IFB No. 27-13 Addendum No. 2

SPRINGFIELD WATER AND SEWER COMMISSION
SPRINGFIELD, MASSACHUSETTS
PLANS AND SPECIFICATIONS FOR CONSTRUCTION OF
SPRINGFIELD RESERVOIR CULVERT REPLACEMENT
PROJECT
SWSC Invitation for Bids No. 27-13

ADDENDUM NO. 2

G-002

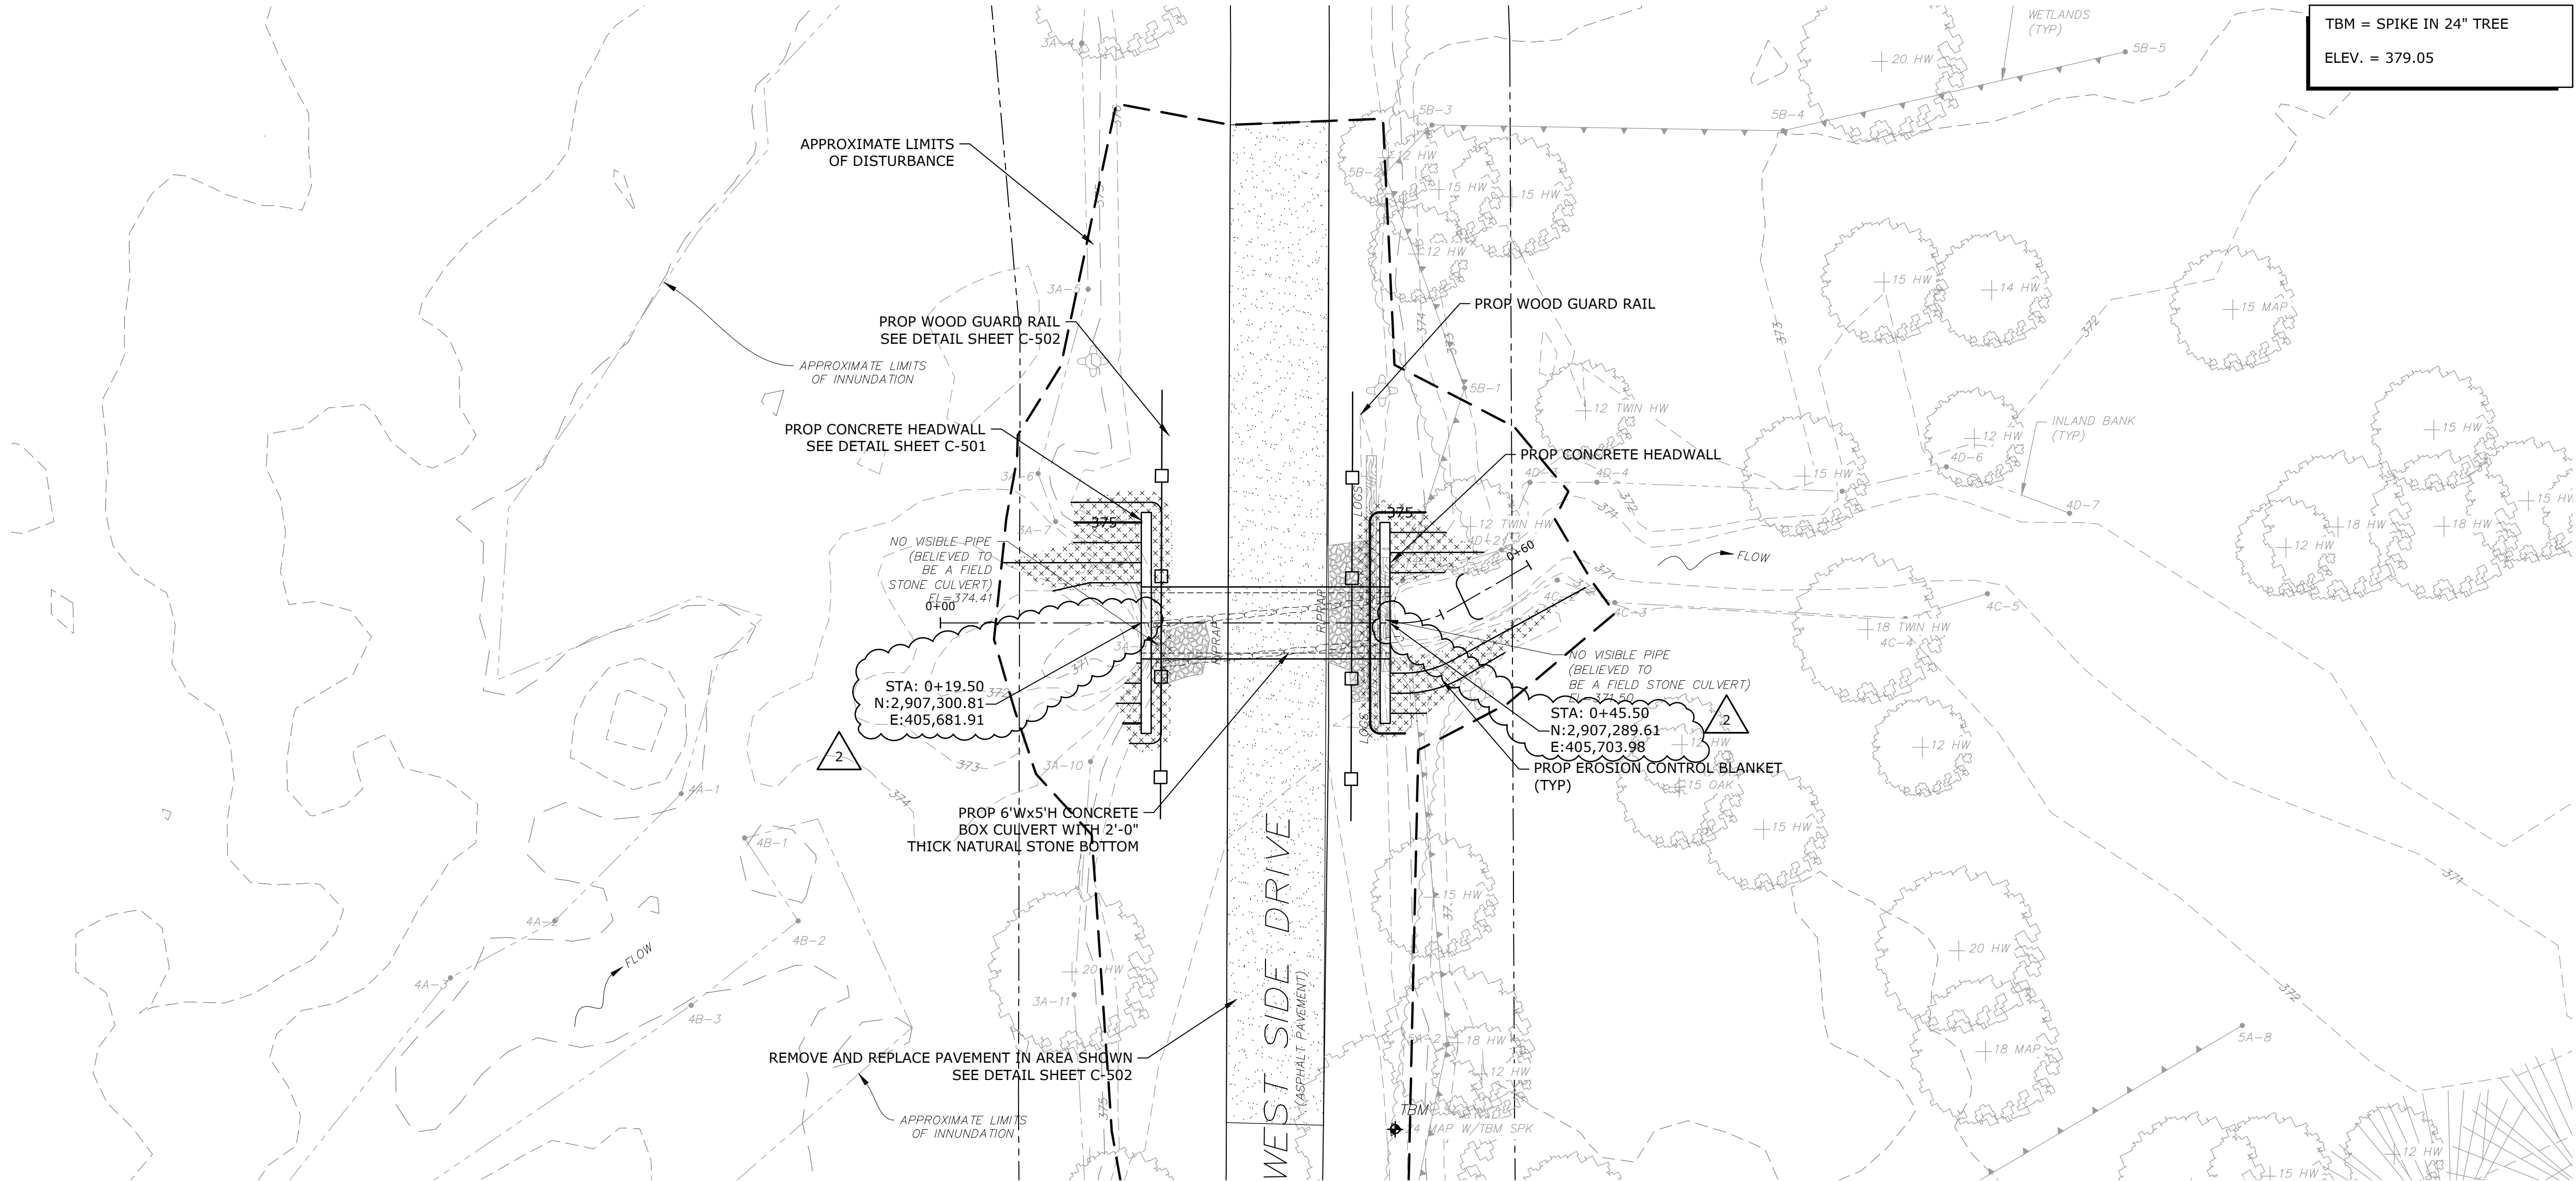
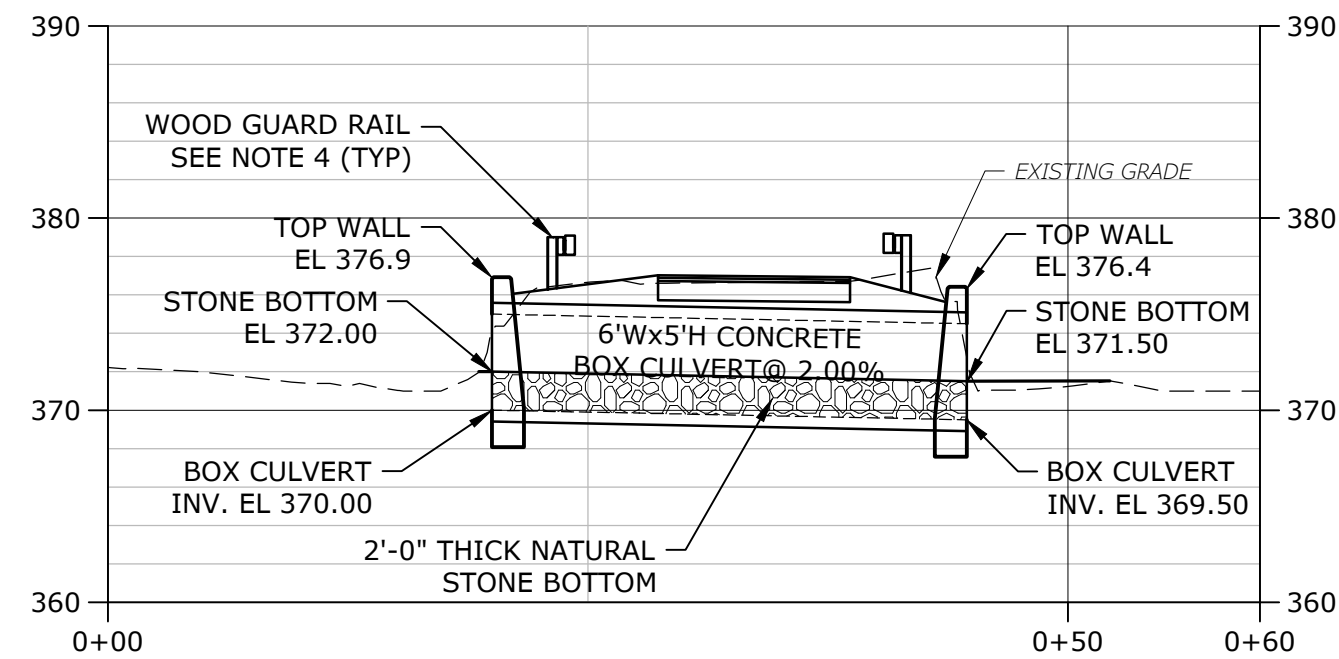
A. G-002 – Legend and General Notes

- a. Added site-access control, signage, gate-operation, gate-attendant/spotter, and Contractor-responsibility requirements

The Contractor shall supplement these measures at other locations directed by SWSC. Revised Sheet G-002 will include the applicable site-access-control and signage requirements.

- COMPLY WITH THE EXCAVATION, BACKFILL, AND COMPACTION REQUIREMENTS OUTLINED IN SPECIFICATION SECTION 02315 FOR CULVERT AND HEADWALL CONSTRUCTION.
- SWSC RETAINS AUTHORITY OVER ACCESS TO THE RESERVOIR PROPERTY. THE CONTRACTOR SHALL CONTROL ACCESS TO THE ACTIVE CONSTRUCTION AREA AND PROVIDE AND MAINTAIN TEMPORARY BARRIERS, FENCING, BARRICADES, AND WEATHER-RESISTANT SIGNAGE NECESSARY TO PREVENT UNAUTHORIZED ENTRY. SIGNS SHALL BE LOCATED, AT A MINIMUM, AT THE RESERVOIR PROPERTY ENTRANCE, THE EXISTING ACCESS GATE, EACH PEDESTRIAN OR BICYCLE APPROACH TO THE WORK, AND EACH END OF THE ACTIVE CONSTRUCTION AREA. SIGNS SHALL INCLUDE THE FOLLOWING MESSAGES AS APPLICABLE: "CONSTRUCTION AREA - NO UNAUTHORIZED ENTRY," "NO PEDESTRIAN ACCESS," AND "DANGER - CONSTRUCTION EQUIPMENT".

- THE EXISTING GATE SHALL REMAIN IN PLACE AND SHALL BE OPERATED IN ACCORDANCE WITH SWSC'S ACCESS REQUIREMENTS. WHENEVER THE GATE IS OPEN FOR CONTRACTOR VEHICLES OR EQUIPMENT, THE CONTRACTOR SHALL PROVIDE A DESIGNATED GATE ATTENDANT/SPOTTER TO CONTROL CONSTRUCTION TRAFFIC, PREVENT UNAUTHORIZED ENTRY INTO THE ACTIVE CONSTRUCTION AREA, AND ASSIST WITH SAFE VEHICLE MOVEMENTS. THE GATE SHALL NOT BE LEFT OPEN UNATTENDED AND SHALL BE CLOSED AND SECURED FOLLOWING EACH USE UNLESS OTHERWISE DIRECTED BY SWSC.

**PROPOSED CONDITIONS
PLAN - CULVERT 1**

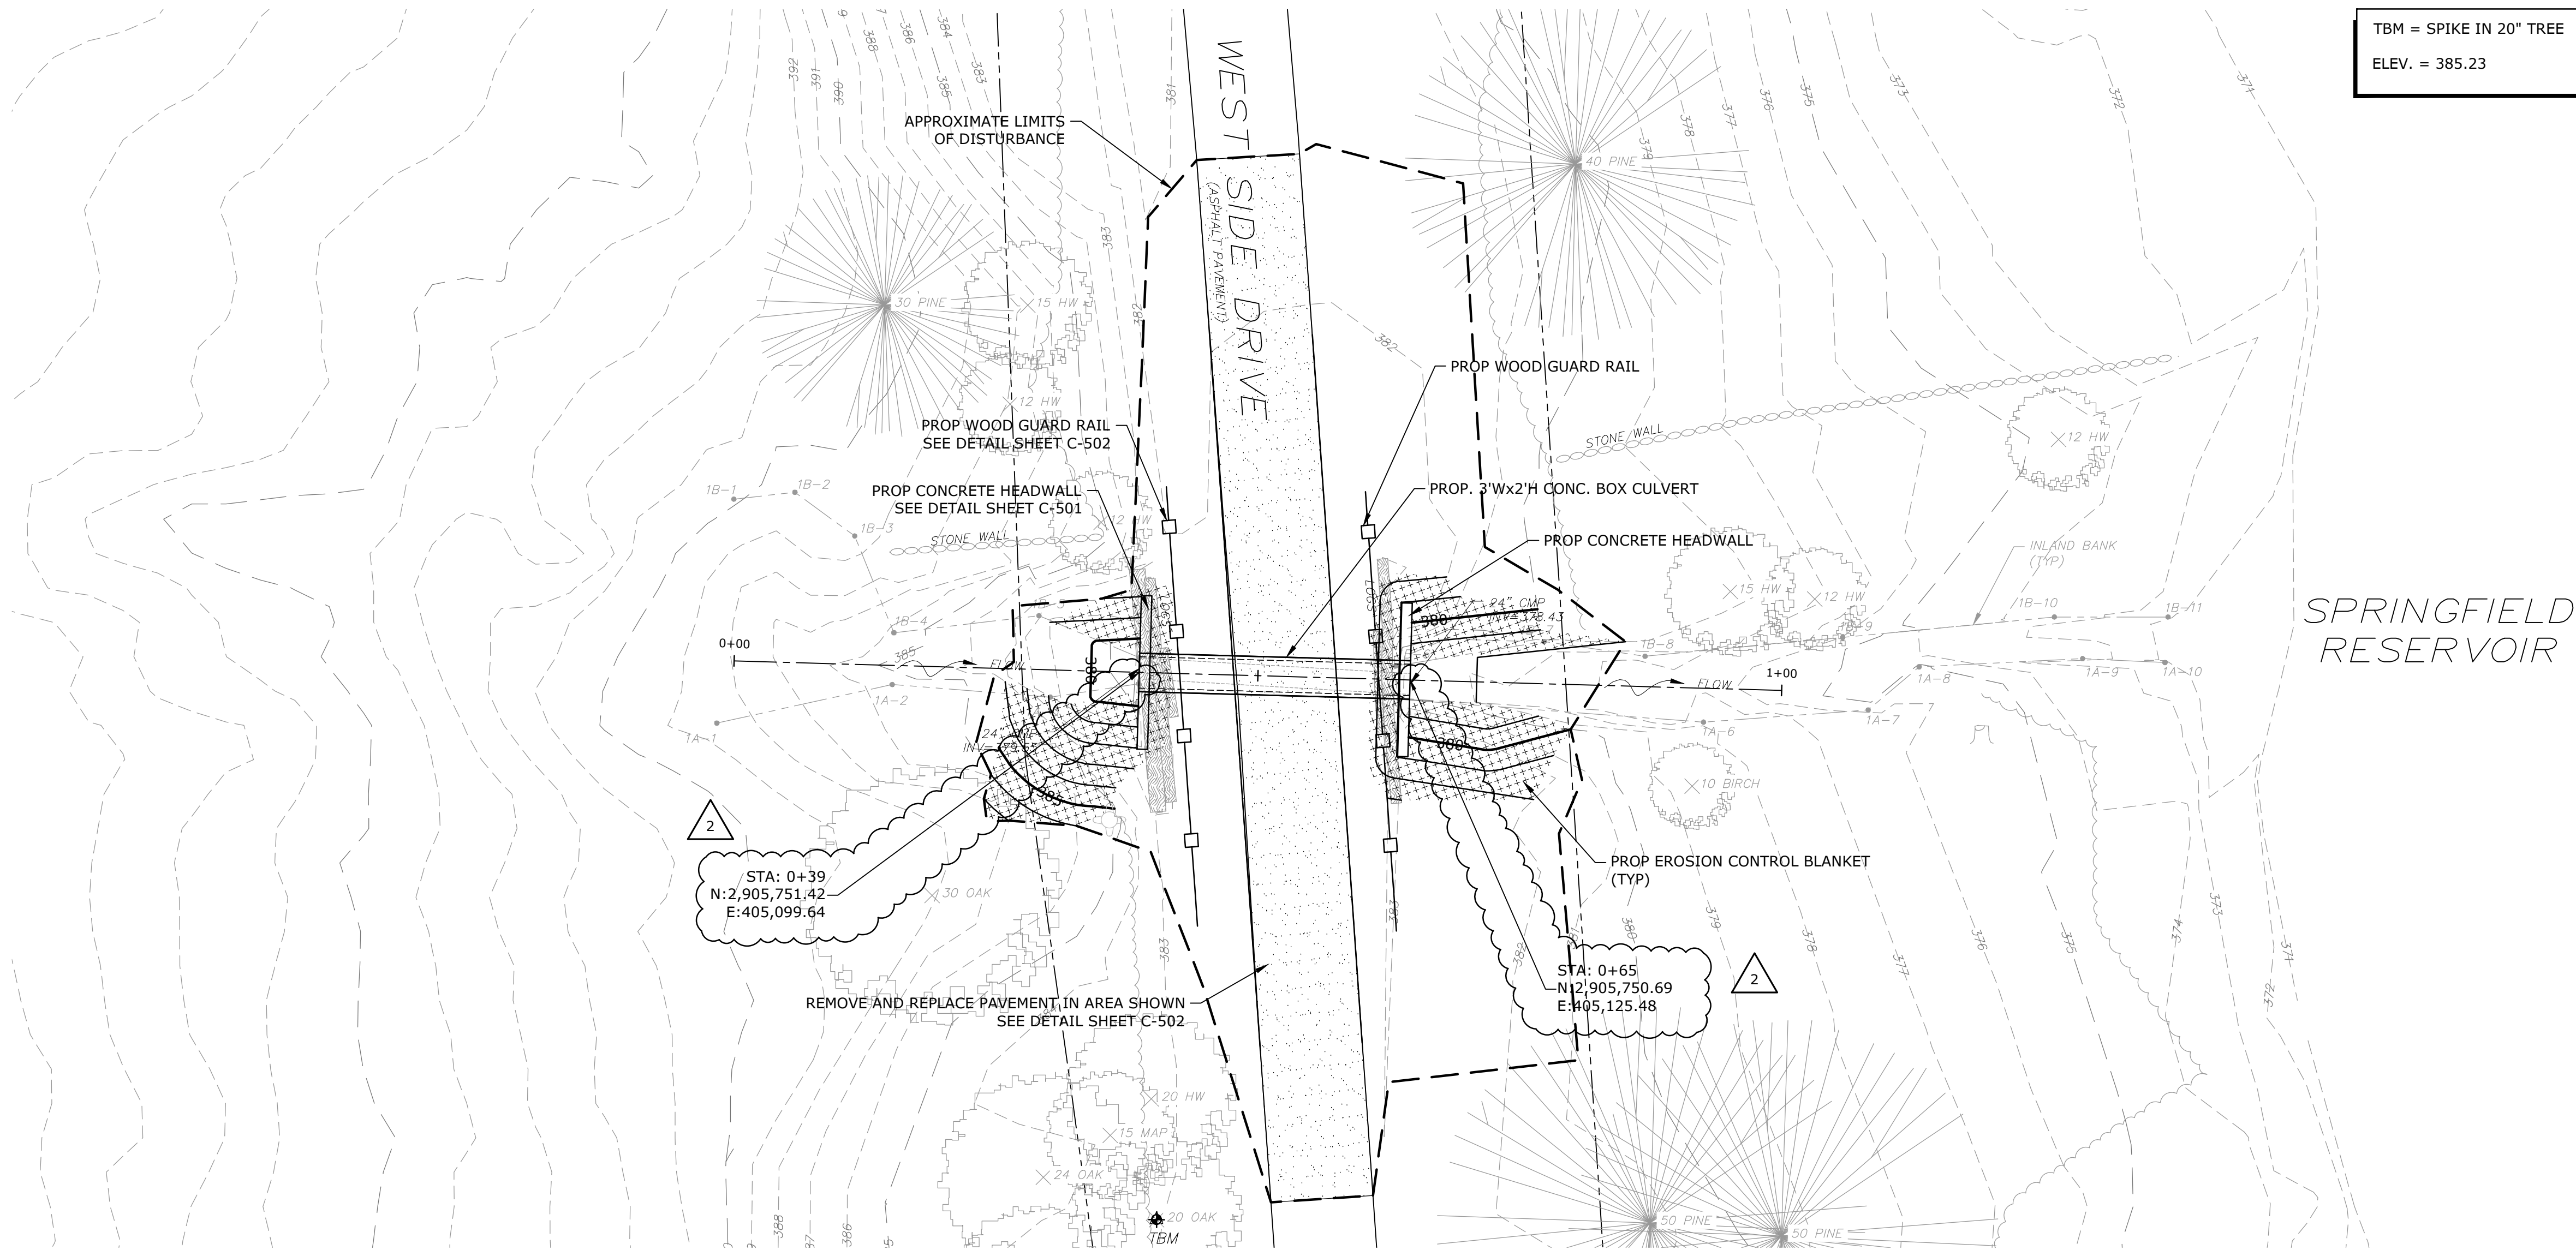
B. C-103 – Proposed Conditions Plan – Culvert 1

- a. Added beginning and ending stationing and coordinate information for Culvert 1

Question 1: Can the lengths of both culverts be provided? The stationing is not listed for the beginning and end of each culvert.

Response 1: Both proposed culverts have an estimated installed length of approximately 26 linear feet. Revised Sheet C-103 identifies the limits of Culvert 1 from approximately Station 0+19.50 to Station 0+45.50. Revised Sheet C-106 identifies the limits of Culvert 2 from approximately Station 0+39 to Station 0+65. The revised sheets also provide coordinate information for the beginning and end of each culvert.

C-106

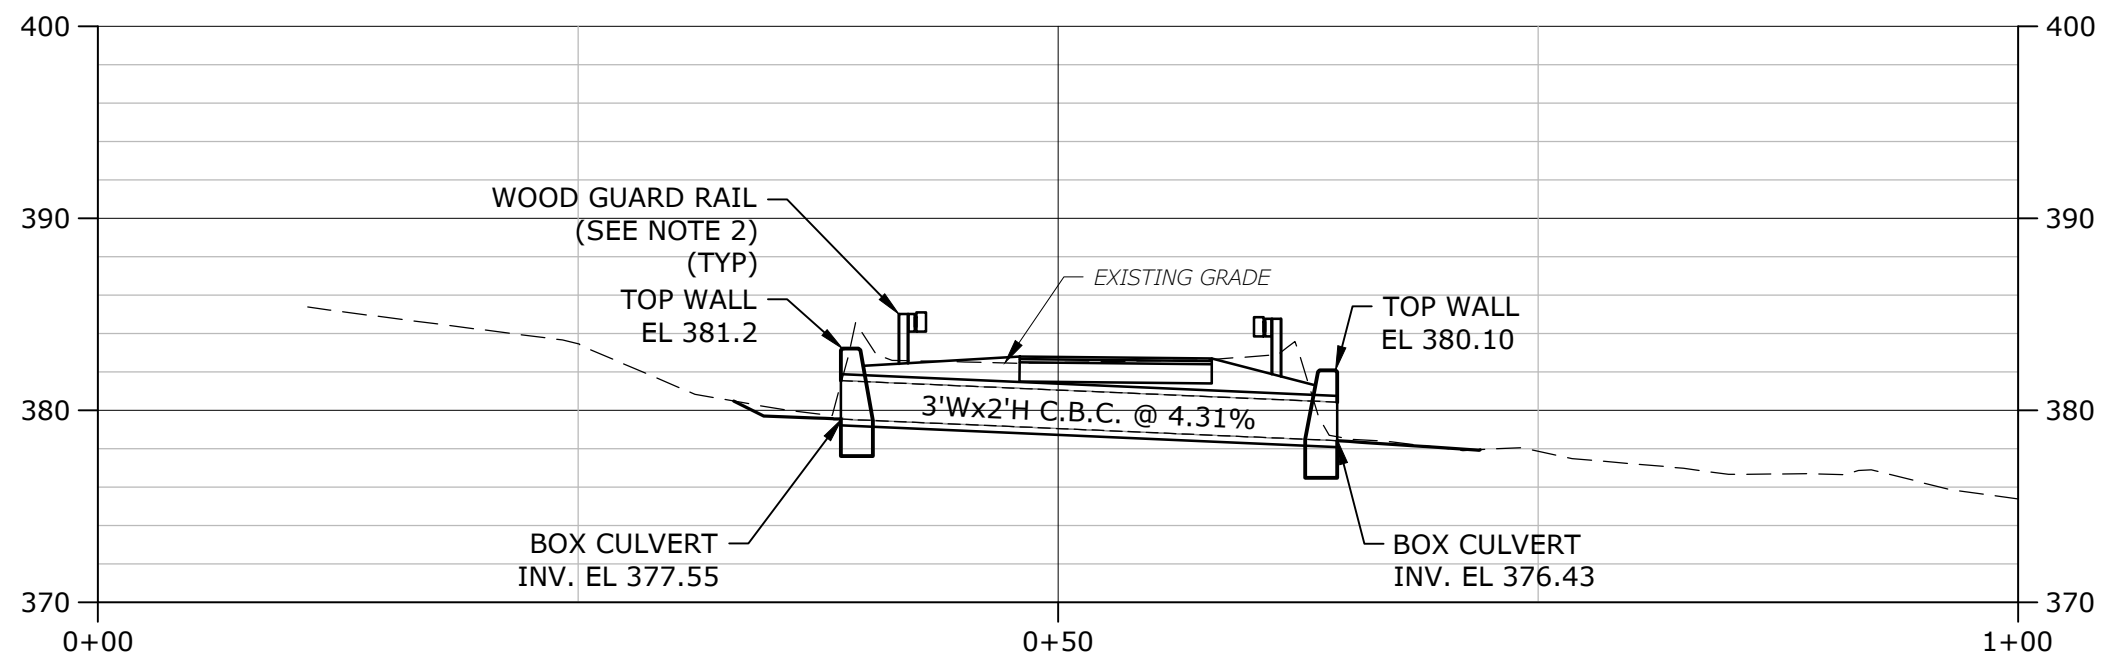
C. C-106 – Proposed Conditions Plan – Culvert 2

- a. Added beginning and ending stationing and coordinate information for Culvert 2
